Access Compliance Report

Public Rights-of-Way

(Curb Ramps)

Intersection ID: 10016341	Main Street: UNIVERSITY_CITY_BV	Cross Street: N/A	Location: NE
ADA ID: 131683A730DC	Ramp Type: Directional2	Initial Pass/Fail: Fail	Overall Compliance: No
Severity Score: 13.75			
Codes/Mitigation Info/Possible Solution		Field Measurements/Component Compliance

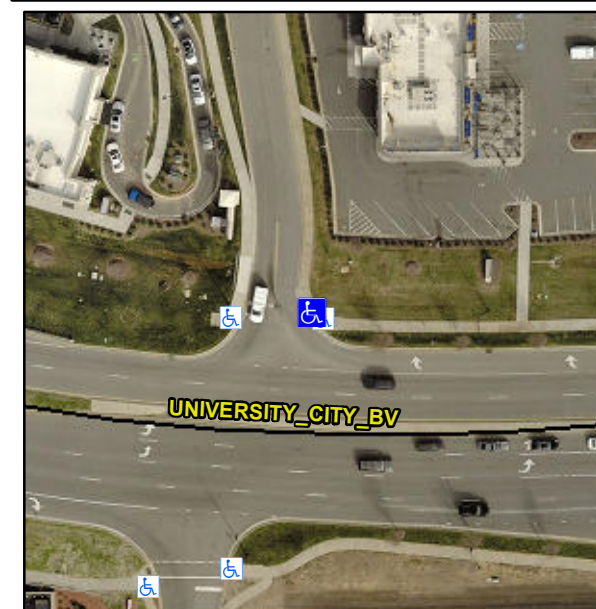
MEDIAN ACROSS UNIVERSITY CITY BV

R304.2.2, R304.5.3

Compliance	Description	Data	Compliance	Description	Data
N/A	Ramp Length (in)	96.0	N/A	Grade Break?	N/A
Yes	Ramp Width (in)	57.0	N/A	Grade Break Slope (%)	0.0
No	Ramp Slope (%)	9.0	N/A	Grade Break XSlope (%)	0.0
No	Ramp XSlope (%)	2.9			
N/A	Flare Type LT	N/A	N/A	Flare Type RT	N/A
N/A	Flare Slope LT (%)	N/A	N/A	Flare Slope RT (%)	0.0
N/A	Flare Traversable LT?	N/A	N/A	Flare Traversable RT?	N/A
N/A	Landing Length (in)	0.0	N/A	DWS Provided?	N/A
N/A	Landing Width (in)	0.0	N/A	DWS Contrast?	N/A
N/A	Landing Slope (%)	0.0	N/A	DWS Length (in)	N/A
N/A	Landing X Slope (%)	0.0	N/A	DWS Full Width?	N/A
N/A	Landing Curb? (Y/N)	N/A	N/A	DWS Offset LT (in)	N/A
N/A	Shared Landing?	N/A	N/A	DWS Offset RT (in)	N/A
N/A	Gutter Ponding?	0.0	N/A	Gutter Slope (%)	N/A
N/A	Gutter Lip Ht (in)	0.0	N/A	Gutter X Slope (%)	N/A
N/A	Painted X Walk1?	No		Road Slope (%)	2.9
	X Walk 1 Direction	To S		Road X Slope (%)	2.8
	X Walk 1 Width (in)	N/A		Clear Space?	N/A

Remove & Replace Entire Ramp.
